**MASTER DEVELOPMENT
DRAINAGE PLAN
FOR
DAVIS RANCH SKETCH PLAN,
EL PASO COUNTY, COLORADO**

June 2023

SKP232

PROPOSED DRAINAGE MAP
DAVIS RANCH
JOB NO. 25274.00
06/30/23
SHEET 1 OF 1

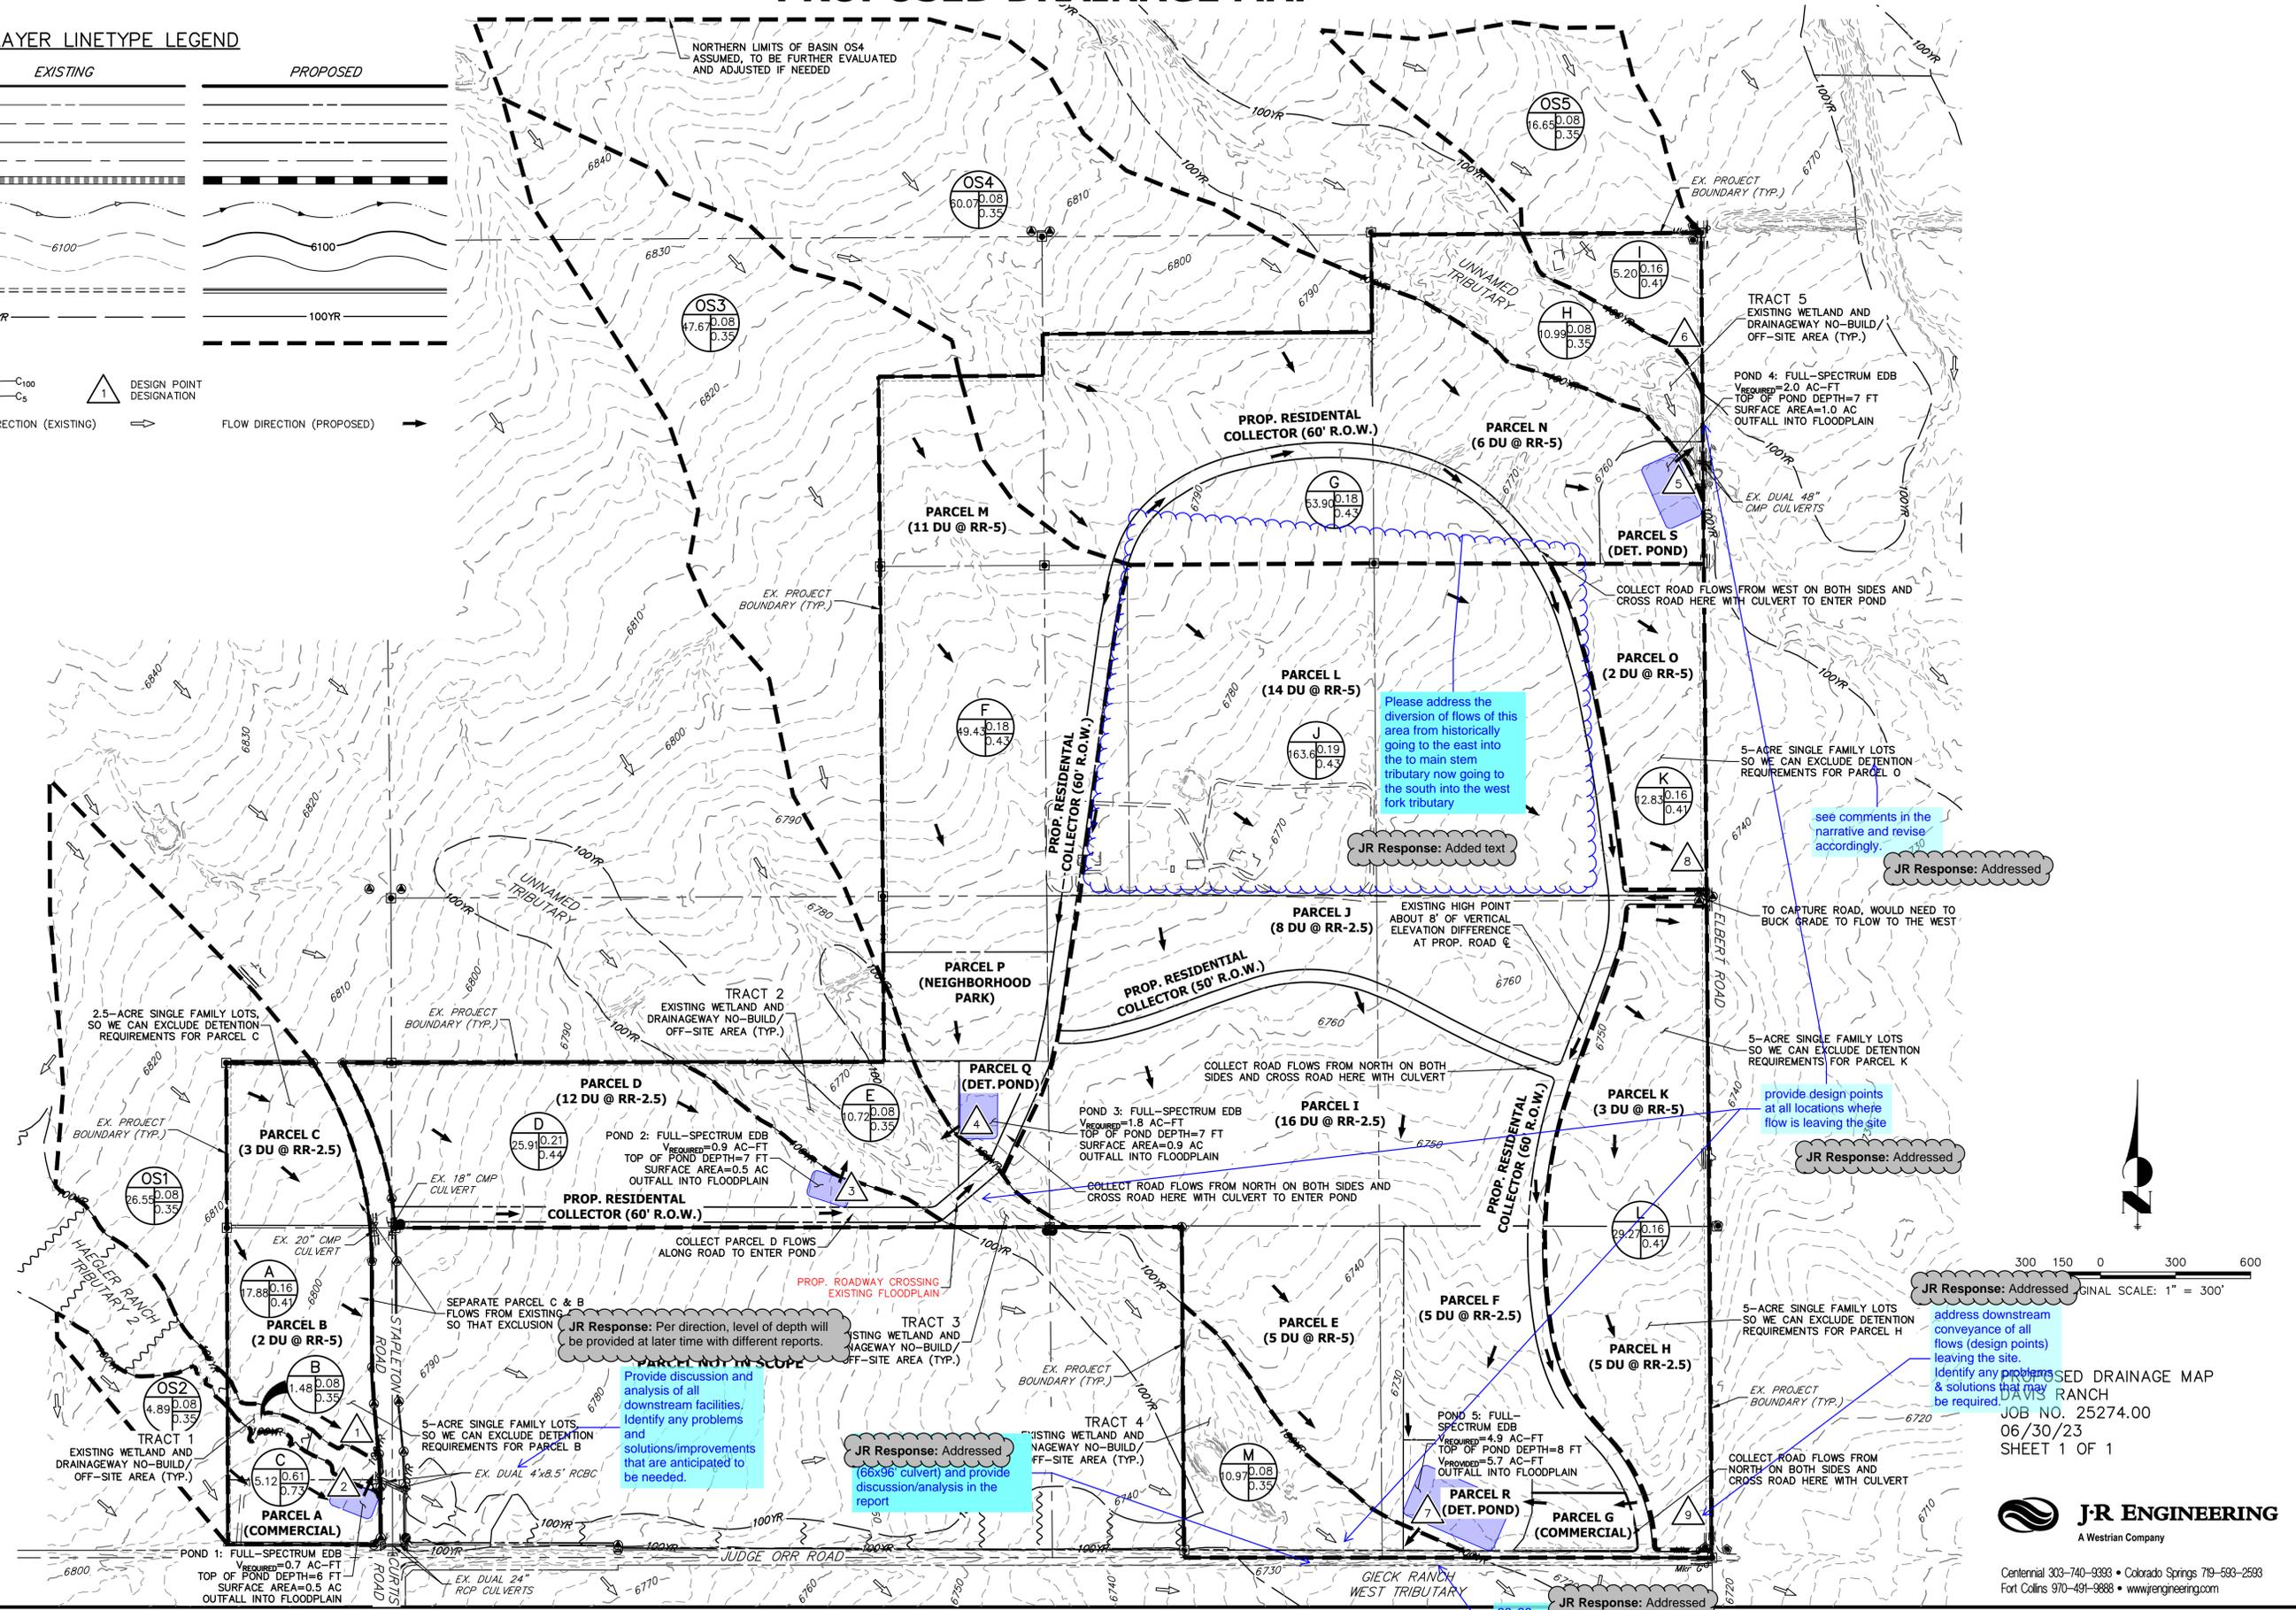
Show discharge points as well and clearly show all basins that contribute to the DPs. Do the ponds correspond with DPs? Please indicate which DPs the pond correspond with in the summary table

JR Response: Addressed

PROPOSED WATER QUALITY MAP
DAVIS RANCH
JOB NO. 25274.00
06/30/23
SHEET 1 OF 1

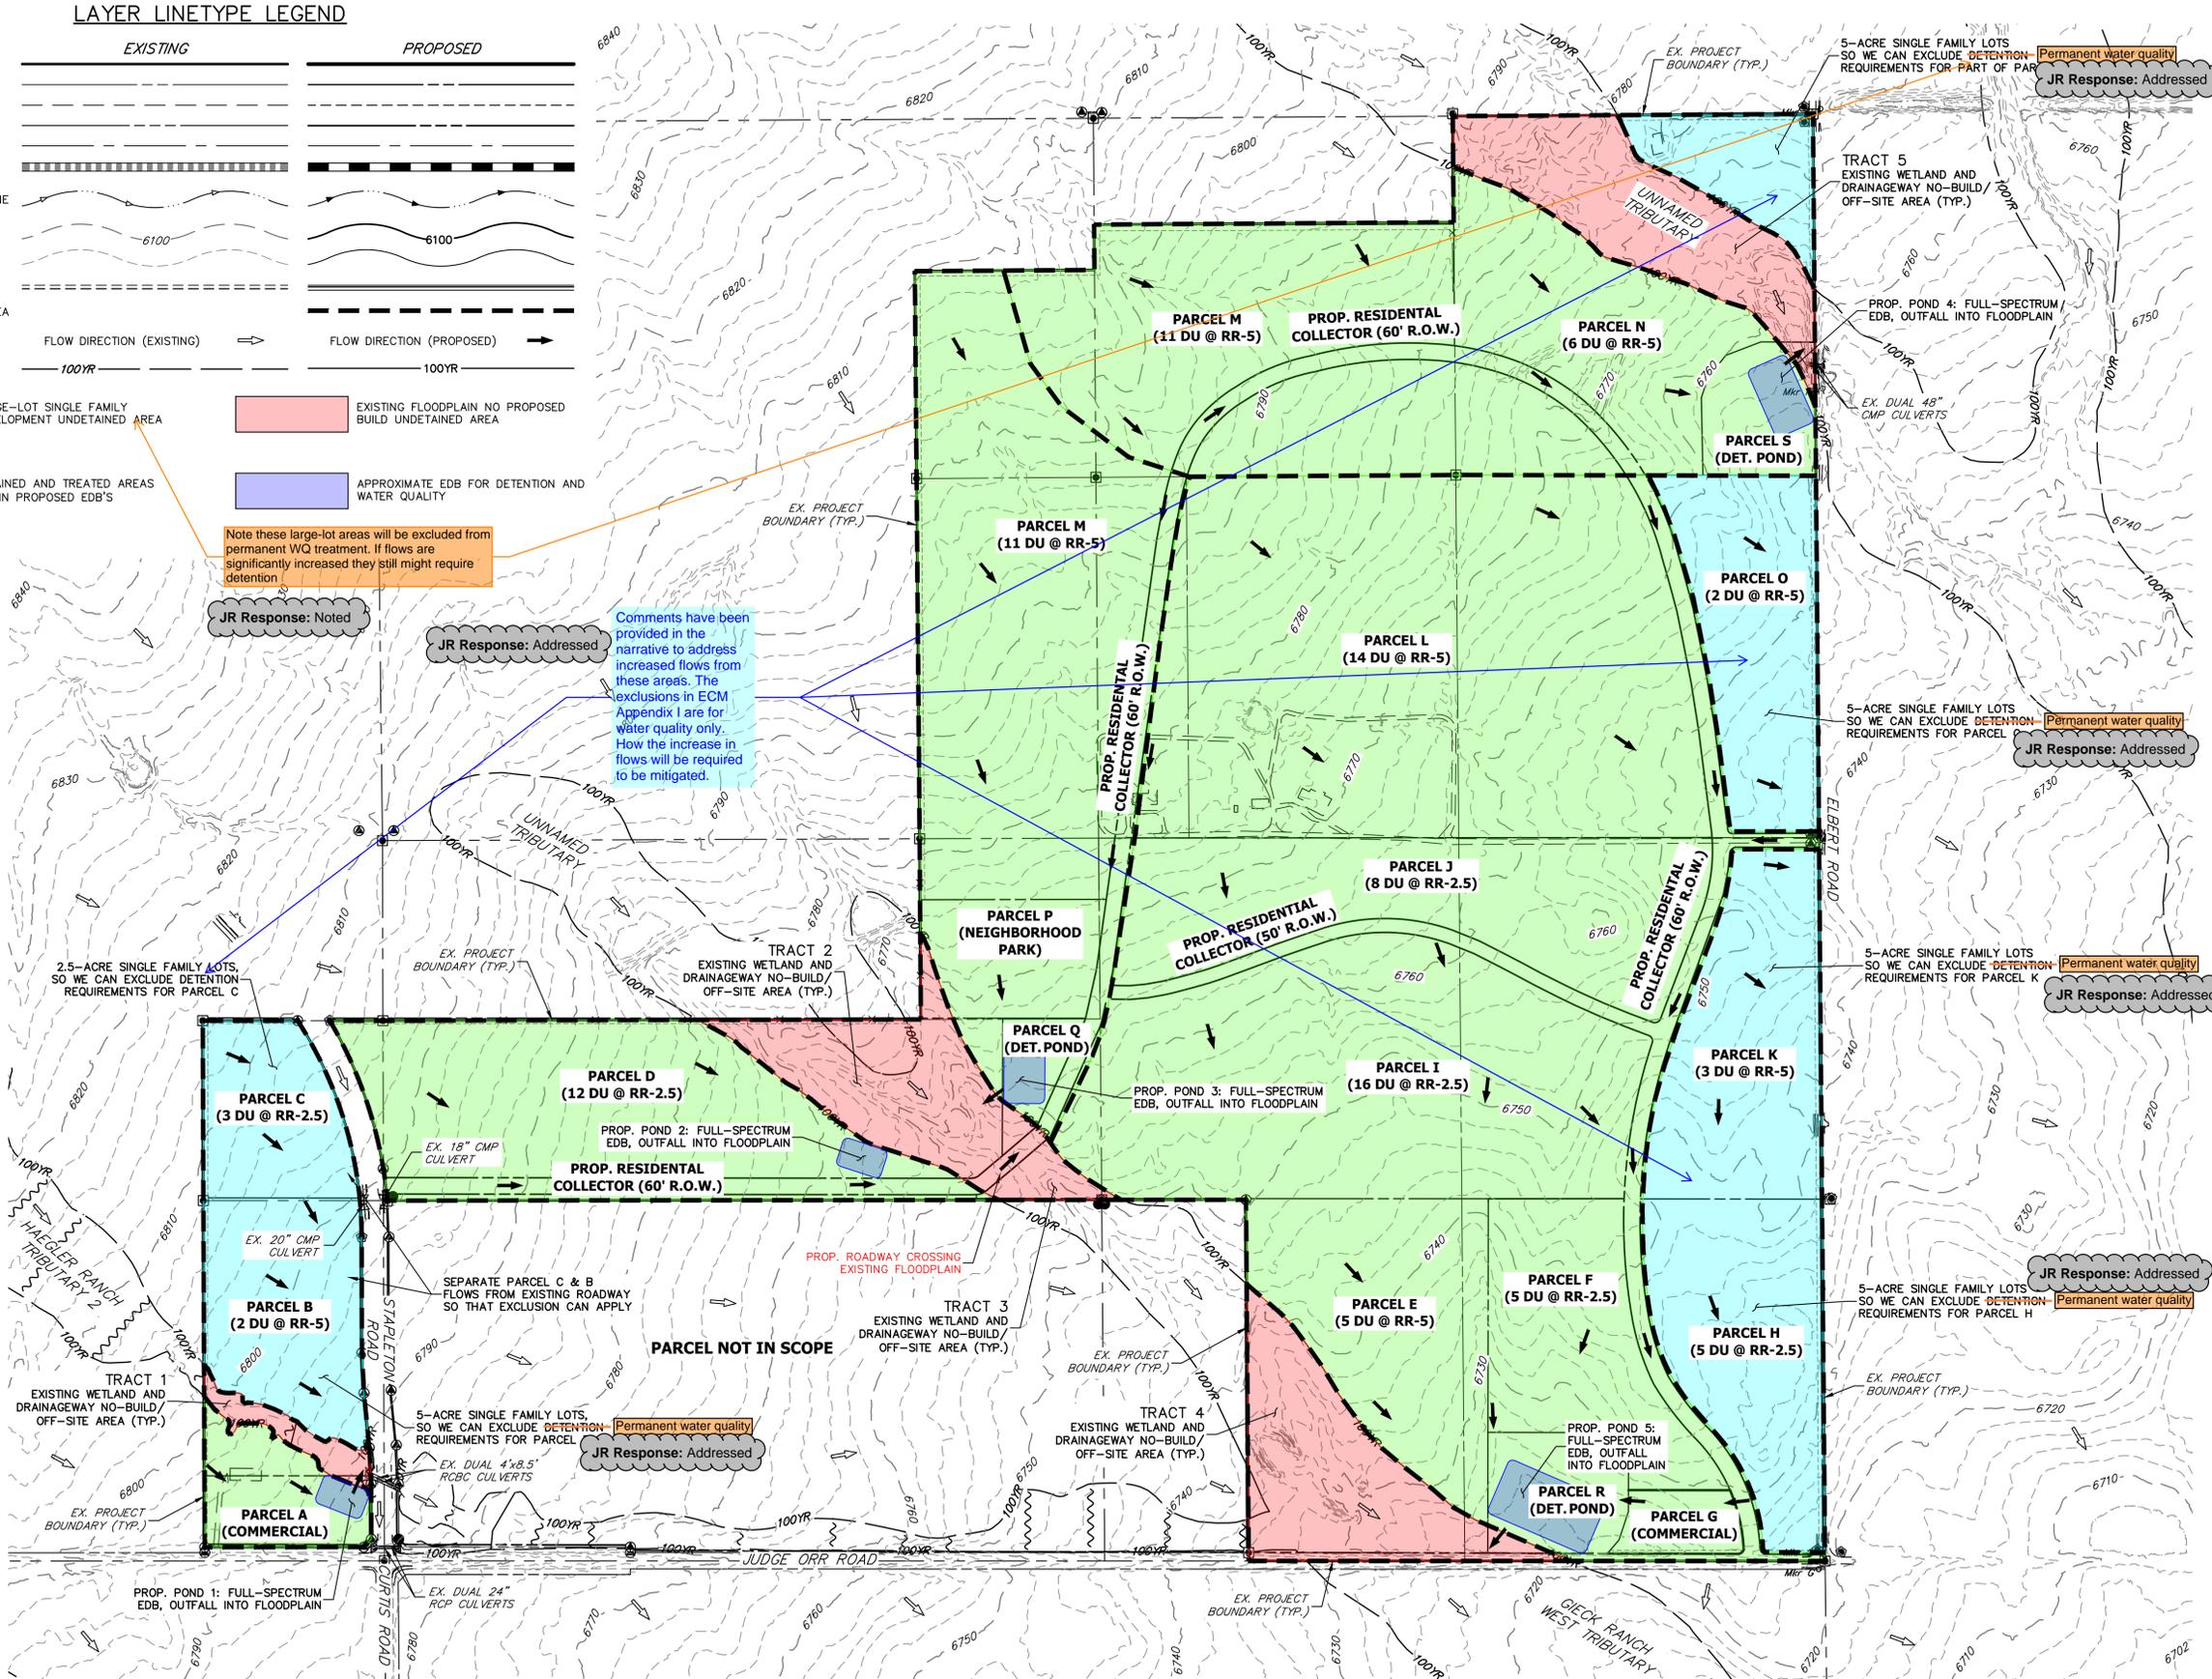
Comments have been provided in the narrative to address increased flows from these areas. The exclusions in ECM Appendix I are for water quality only. How the increase in flows will be required to be mitigated.

JR Response: Addressed
